MOUNT EMMONS

Mining Project
ENVIRONMENTAL
IMPACT
STATEMENT

FINAL

FINAL ENVIRONMENTAL IMPACT STATEMENT
MT. EMMONS PROJECT
GUNNISON COUNTY, COLORADO
02-04-81-03

Figure: 4-22 STATUS OF TOTAL, PROJECT INVOLVED, WETLANDS

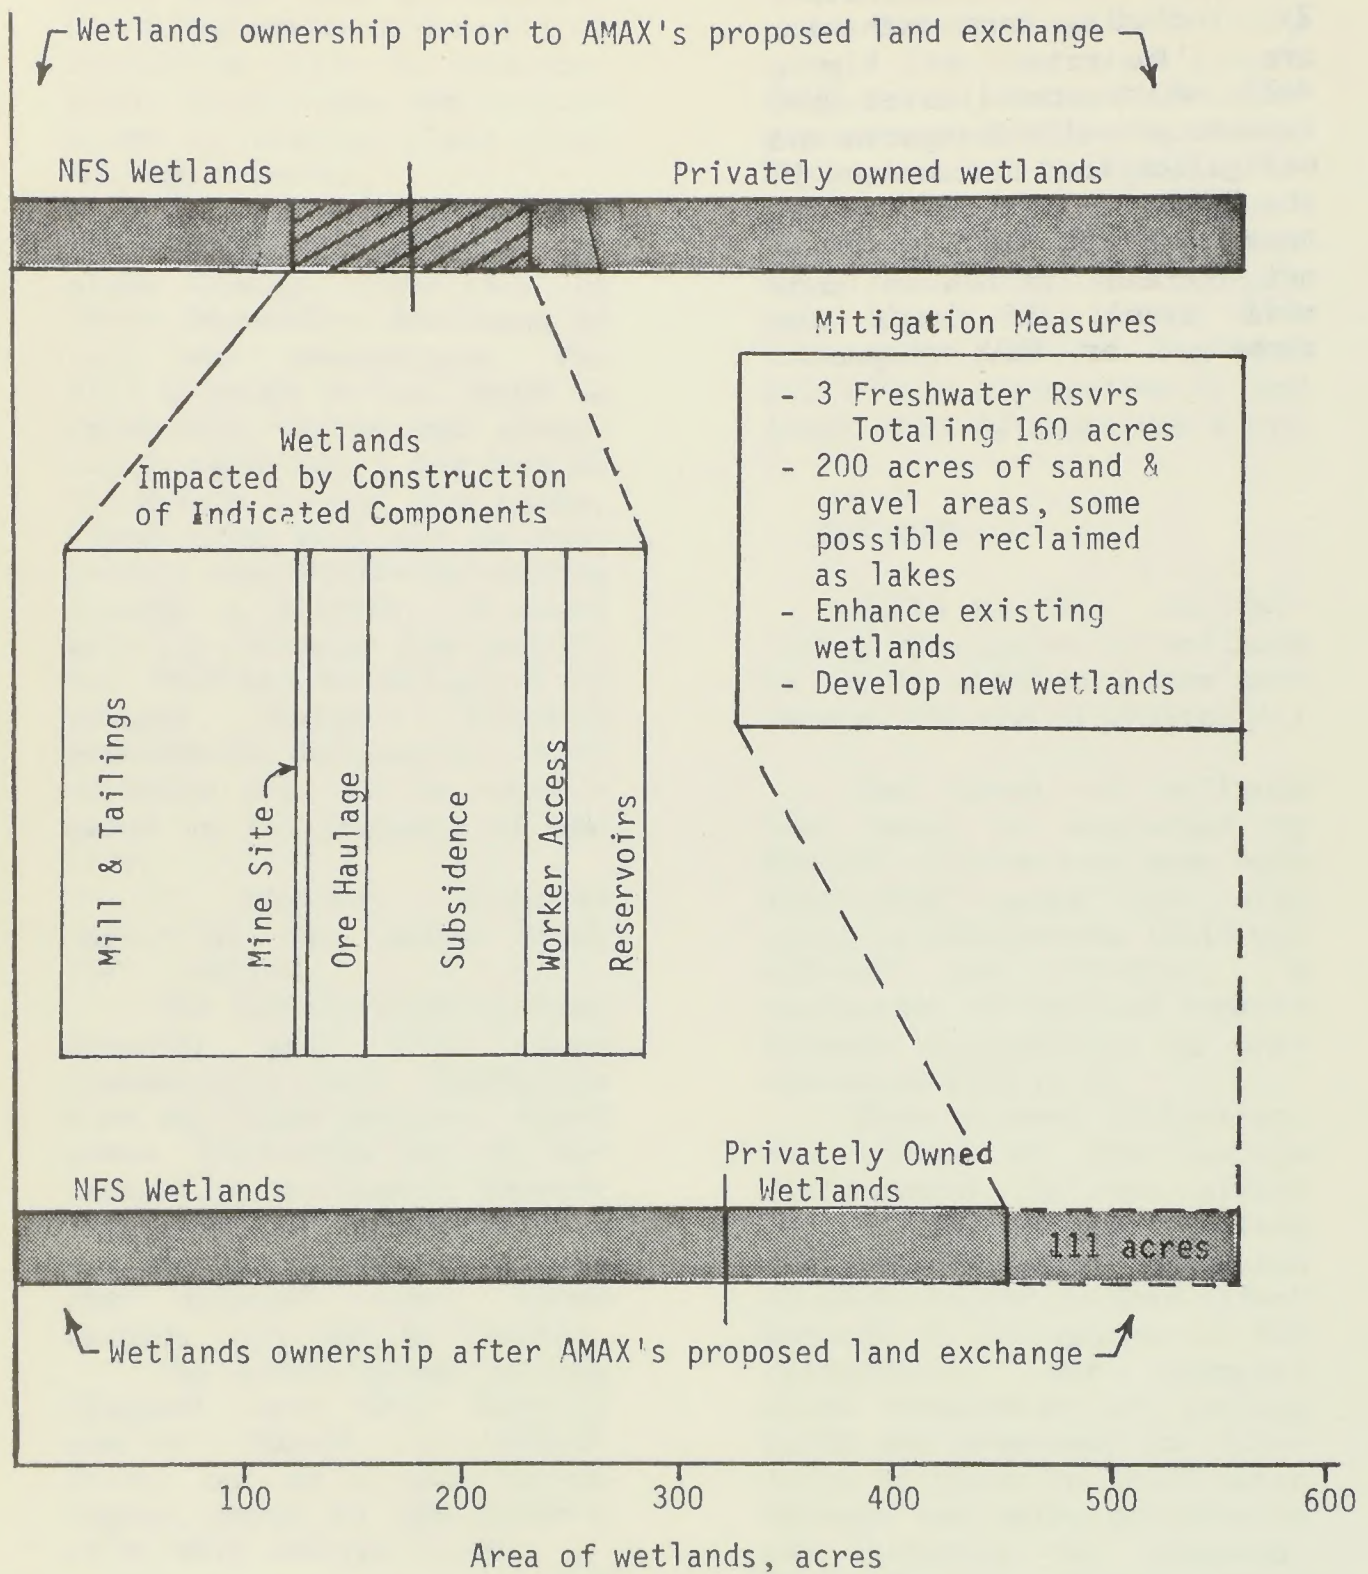
A comparison of riparian disturbances is shown in the following figure. Although this information does not precisely agree with Army Corps of Engineers determinations of wetlands disturbed, it does illustrate the relative magnitude of wetlands affected by the alternatives.

FIG. E-7 Revised

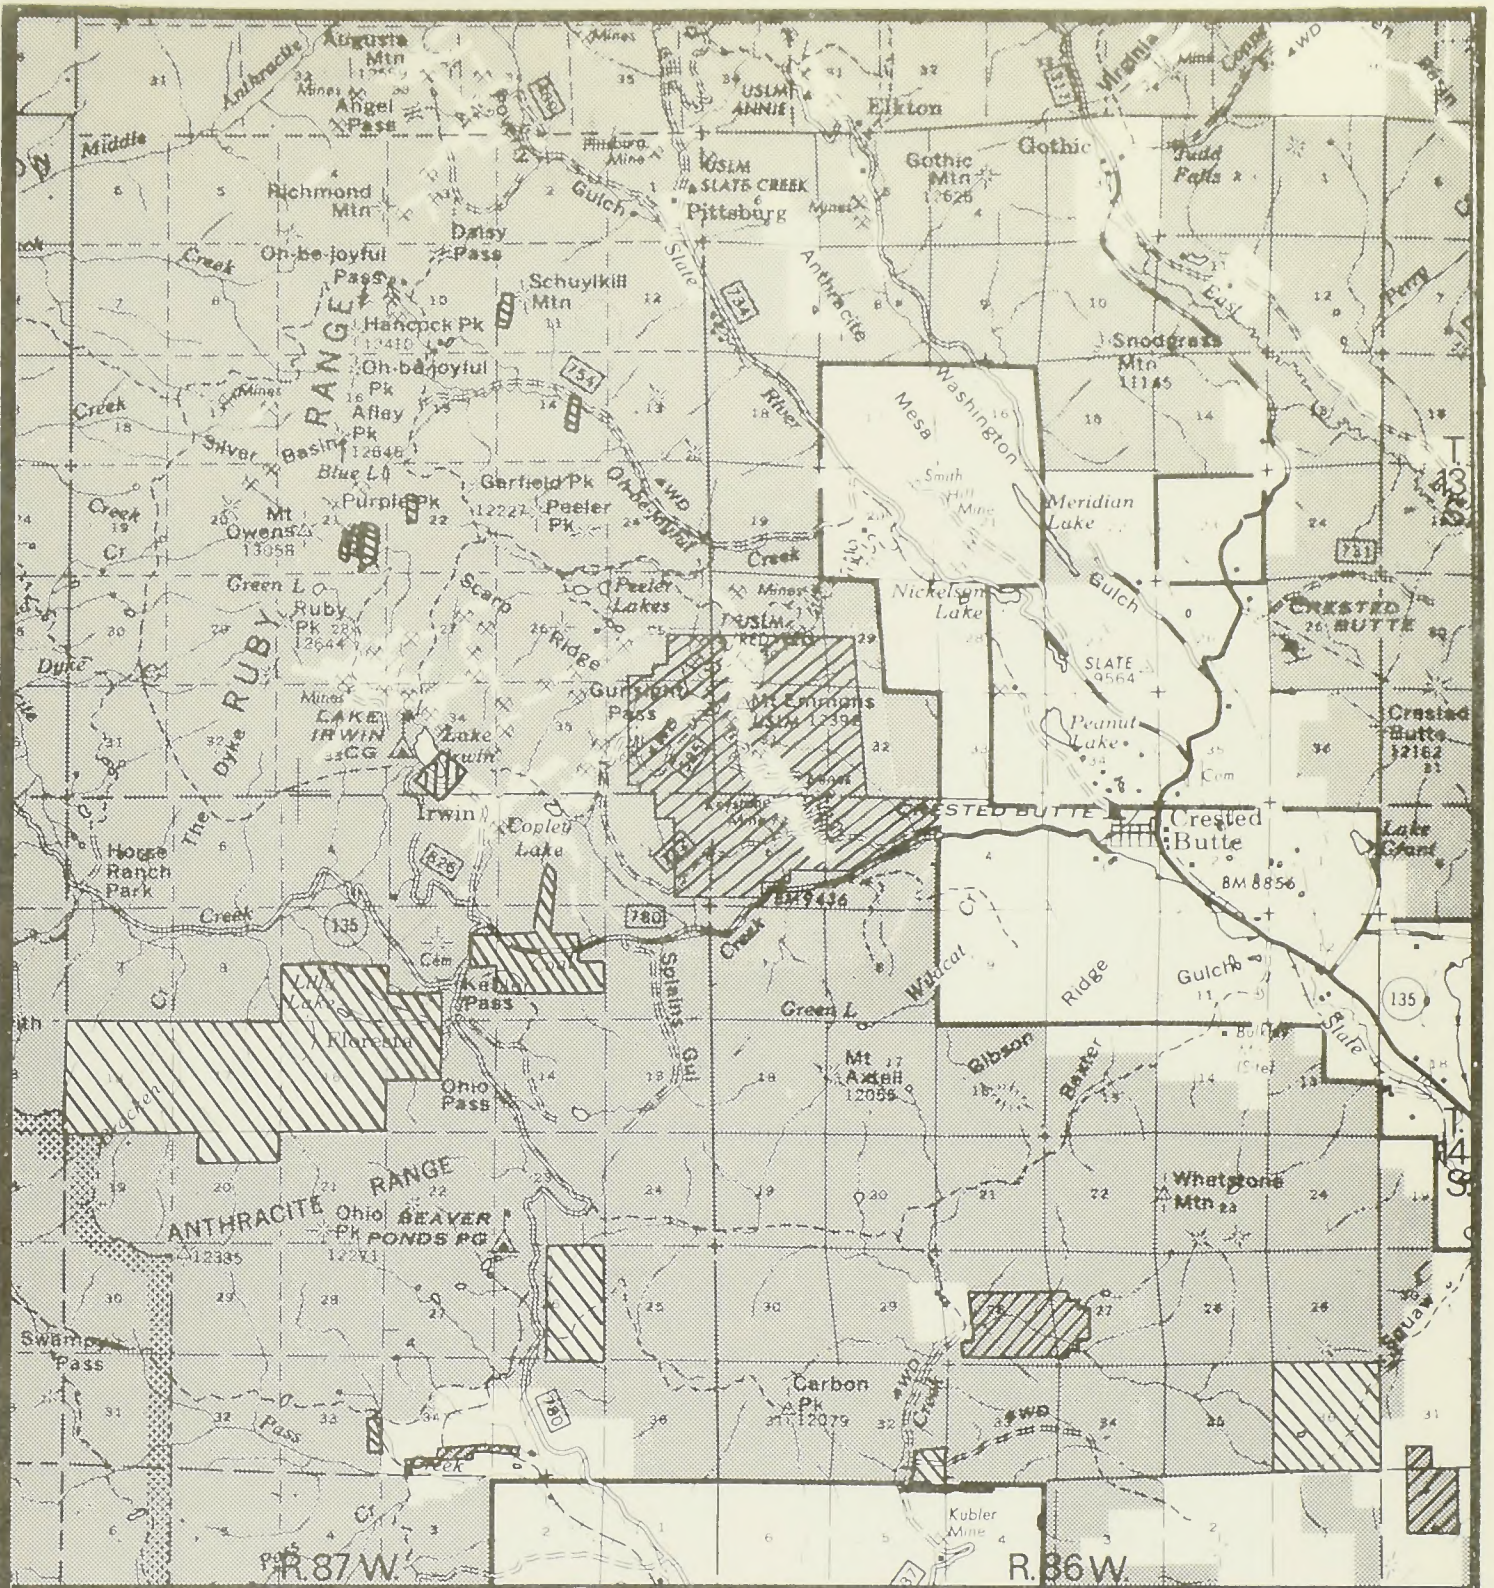
This appendix contains only Figure E-7 showing the proposed classifications which are needed to allow land adjustment programs to be processed if they are in the public interest. Figures E-1 through E-6 and E-8 through E-10 remain unchanged from the DEIS.
